Addendum

Addendum 4th May 2016

The Central Precinct Landscape and Open Space Masterplan of July 2008 has been subject to several refinements that seek to improve open space and recreation outcomes in the Central Precinct and to enhance integration of parkland open space with the Regional Open Space and Regional Park. These refinements have been made possible by ongoing collation of detailed site survey information relating to existing vegetation and in ongoing development of more detailed urban planning within the development area.

Figure 6.1 Open Space Masterplan (revised April 2016)

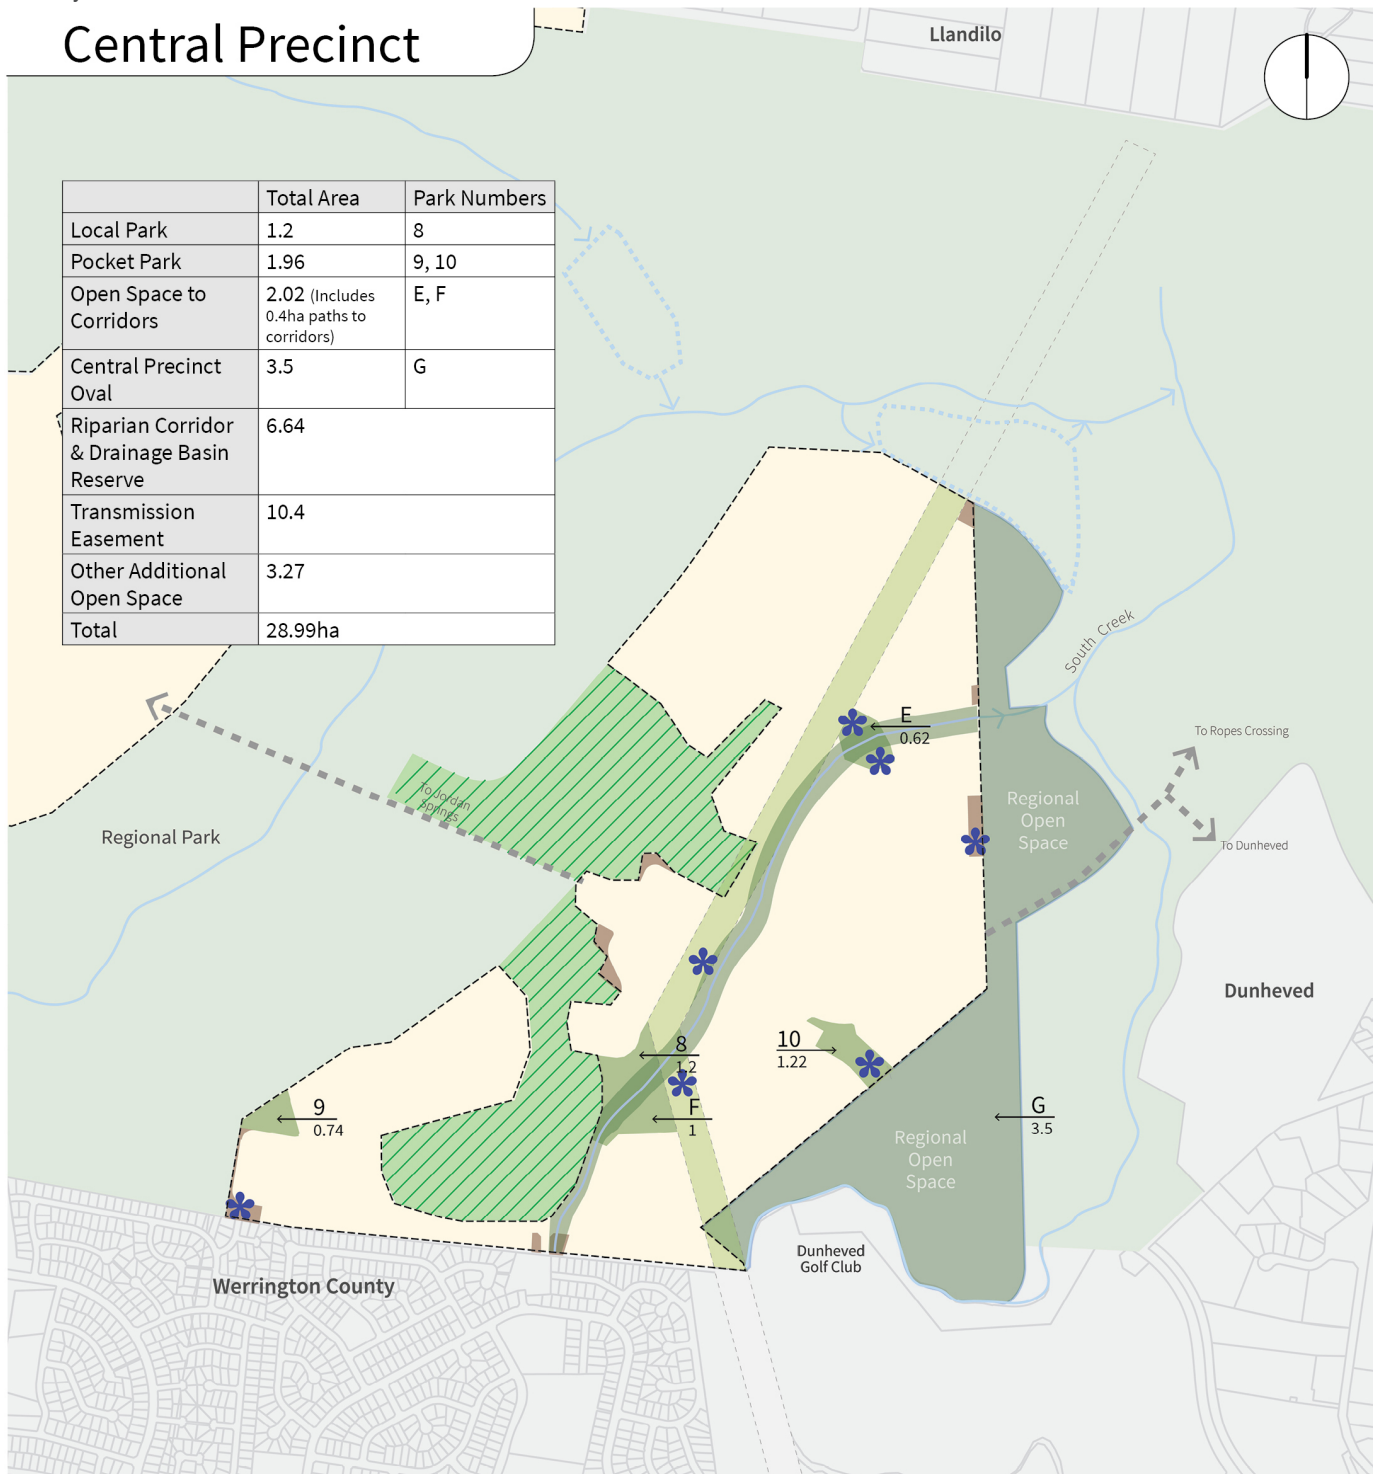
Area of Pocket Park open space has increased and locations have been refined

The total area provided through Pocket Park spaces has increased. The Town Centre Park (10) has increased in size with the proposed relocation of the water quality basin into the Regional Open Space.

Pocket Park (9) has been repositioned for habitat and drainage benefits. The refined location enables retention of quality tree canopy within the open space and offers enhanced potential to assist in the management of drainage into Wianamatta Regional Park.

Pocket Park (10) - Town Centre Park was repositioned in alignment with the relocation of the Town Centre to the southern side of the east west connector road. The Town Centre Park will now better interface and interact with the Central Precinct Oval / Regional Open Space and the town centre.

Open spaces (8) (F) and (E) are all approximately in the locations as defined by the 2008 Landscape and Open Space Masterplan.

Area of Corridor open space has increased

With the minor realignment of the riparian corridor together with the interface with the trans grid easement, the open space to corridor areas has increased. This provides the urban development with better quality of access to open space areas and improved integration between the subdivision, riparian corridor and the trans grid easement.

Central Precinct Oval

The Central Precinct Oval was identified in the 2008 Landscape and Open Space Masterplan to be off set into the Regional Open Space and this is articulated in the development agreements with Penrith City Council. This category of open space is now more specifically referred to as "Central Precinct Oval"

Figure 6.2 Access Masterplan (revised April 2016)

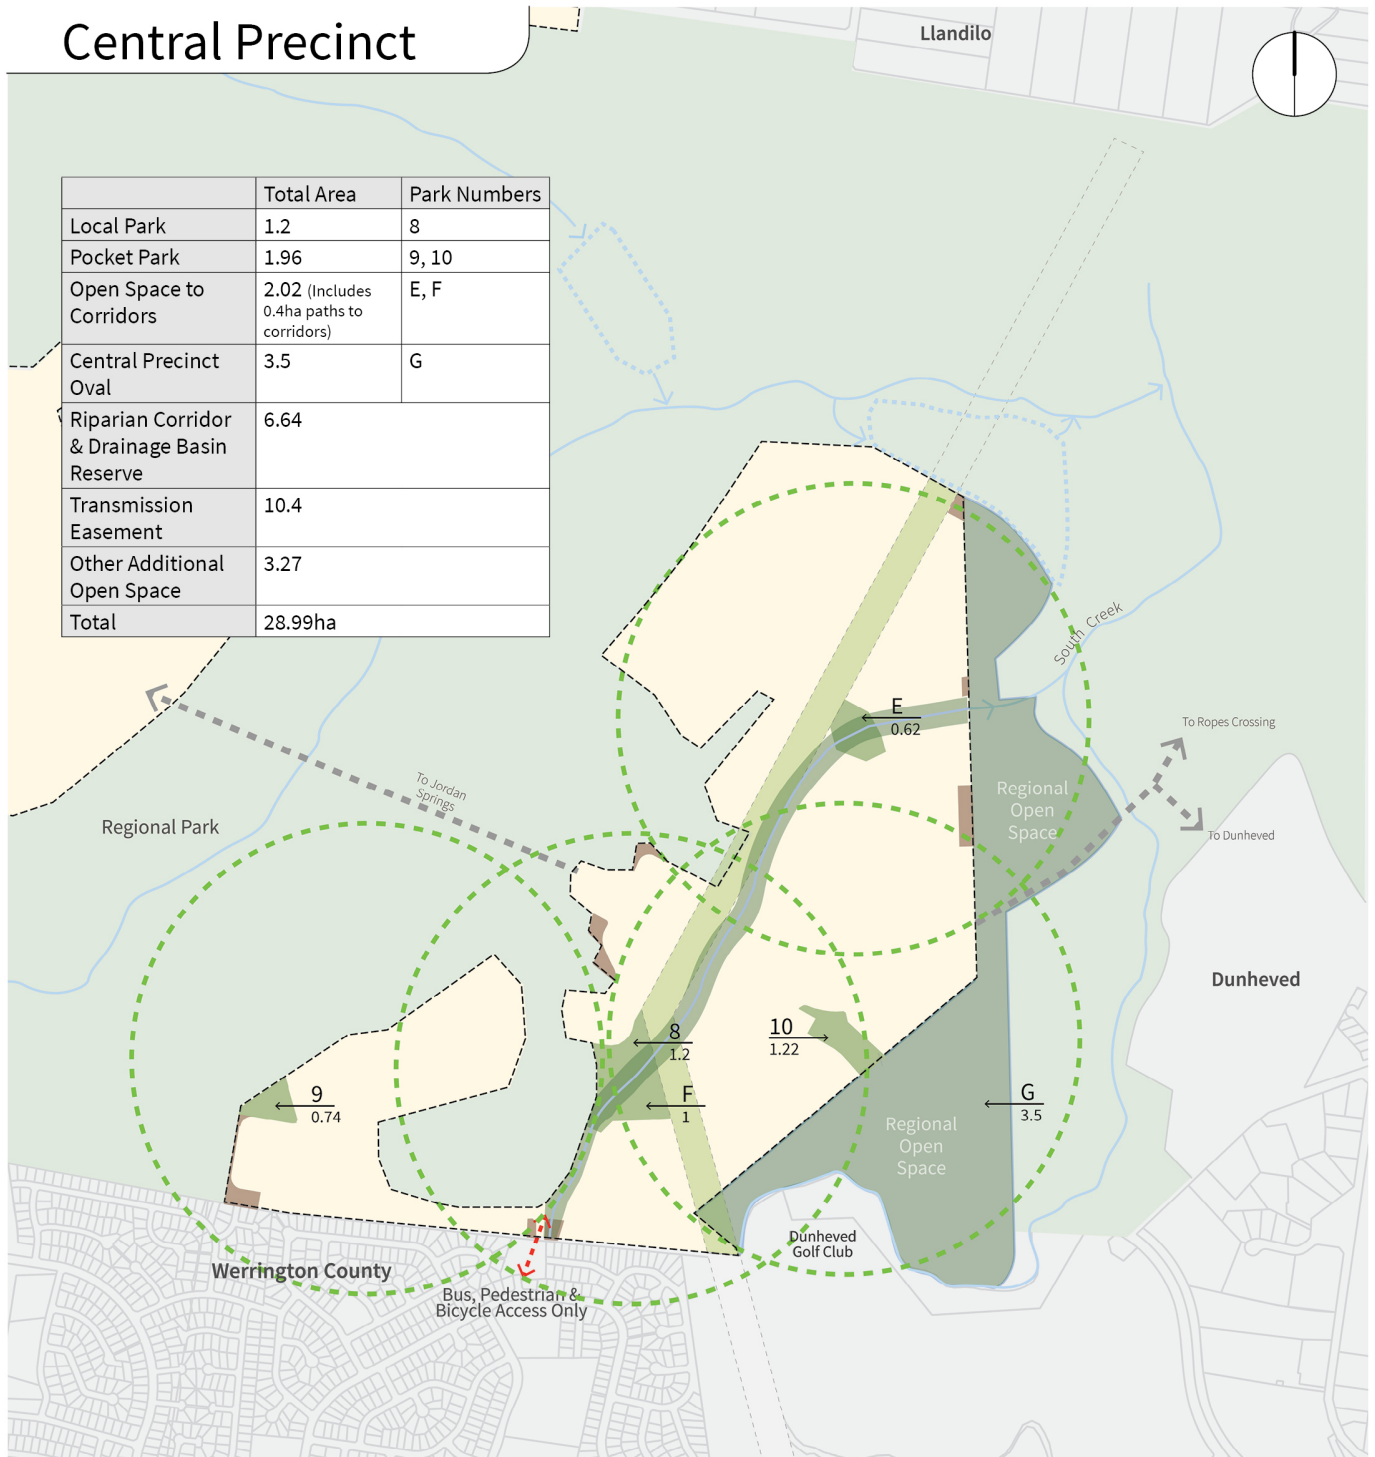
Figure 6.2 following provides an updated Open Space Masterplan (April 2016). This illustrates that access to open space across the site has been marginally improved by the refined layout of open space areas.
